## Product Change Notice (PCN)

PCN Number: **PCN-0450899R-01**

Product(s) Affected: *SJ1-4251X Series. SJ1-42514, SJ1-42515TS & SJ1-42516*

PREVIOUS CUI DEVICES DETAIL / IMAGE	NEW CUI DEVICES DETAIL / IMAGE

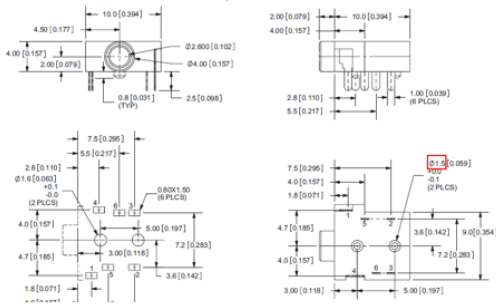
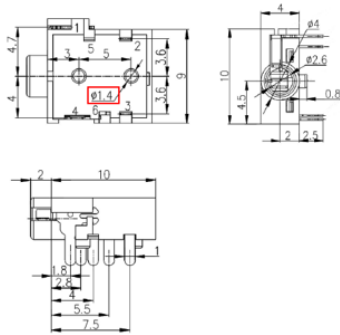
Description of Change: *Locating pin difference and material change. See image Below*

<table border="1"> <thead> <tr> <th></th> <th>MATERIAL</th> <th>PLATING</th> </tr> </thead> <tbody> <tr> <td>terminal 1</td> <td>copper alloy</td> <td>gold flash</td> </tr> <tr> <td>terminal 2</td> <td>copper alloy</td> <td>gold flash</td> </tr> <tr> <td>terminal 3</td> <td>copper alloy</td> <td>gold flash</td> </tr> <tr> <td>terminal 4</td> <td>copper alloy</td> <td>gold flash</td> </tr> <tr> <td>terminal 5</td> <td>brass</td> <td>gold flash</td> </tr> <tr> <td>terminal 6</td> <td>brass</td> <td>gold flash</td> </tr> <tr> <td>plastic</td> <td>PA66</td> <td></td> </tr> </tbody> </table>		MATERIAL	PLATING	terminal 1	copper alloy	gold flash	terminal 2	copper alloy	gold flash	terminal 3	copper alloy	gold flash	terminal 4	copper alloy	gold flash	terminal 5	brass	gold flash	terminal 6	brass	gold flash	plastic	PA66		<table border="1"> <thead> <tr> <th>DESCRIPTION</th> <th>MATERIAL</th> <th>PLATING/COLOR</th> </tr> </thead> <tbody> <tr> <td>terminal 1</td> <td>phosphorous bronze t=0.25</td> <td>gold flash</td> </tr> <tr> <td>terminal 2</td> <td>phosphorous bronze t=0.20</td> <td>gold flash</td> </tr> <tr> <td>terminal 3</td> <td>phosphorous bronze t=0.20</td> <td>gold flash</td> </tr> <tr> <td>terminal 4</td> <td>phosphorous bronze t=0.25</td> <td>gold flash</td> </tr> <tr> <td>terminal 5</td> <td>phosphorous bronze t=0.20</td> <td>gold flash</td> </tr> <tr> <td>terminal 6</td> <td>phosphorous bronze t=0.20</td> <td>gold flash</td> </tr> <tr> <td>housing</td> <td>PA66 [UL94V-0]</td> <td>black</td> </tr> </tbody> </table>	DESCRIPTION	MATERIAL	PLATING/COLOR	terminal 1	phosphorous bronze t=0.25	gold flash	terminal 2	phosphorous bronze t=0.20	gold flash	terminal 3	phosphorous bronze t=0.20	gold flash	terminal 4	phosphorous bronze t=0.25	gold flash	terminal 5	phosphorous bronze t=0.20	gold flash	terminal 6	phosphorous bronze t=0.20	gold flash	housing	PA66 [UL94V-0]	black

MATERIAL	PLATING																																															
terminal 1	copper alloy	gold flash																																															
terminal 2	copper alloy	gold flash																																															
terminal 3	copper alloy	gold flash																																															
terminal 4	copper alloy	gold flash																																															
terminal 5	brass	gold flash																																															
terminal 6	brass	gold flash																																															
plastic	PA66																																																
DESCRIPTION	MATERIAL	PLATING/COLOR																																															
terminal 1	phosphorous bronze t=0.25	gold flash																																															
terminal 2	phosphorous bronze t=0.20	gold flash																																															
terminal 3	phosphorous bronze t=0.20	gold flash

terminal 4	phosphorous bronze t=0.25	gold flash																																															
terminal 5	phosphorous bronze t=0.20	gold flash																																															
terminal 6	phosphorous bronze t=0.20	gold flash																																															
housing	PA66 [UL94V-0]	black
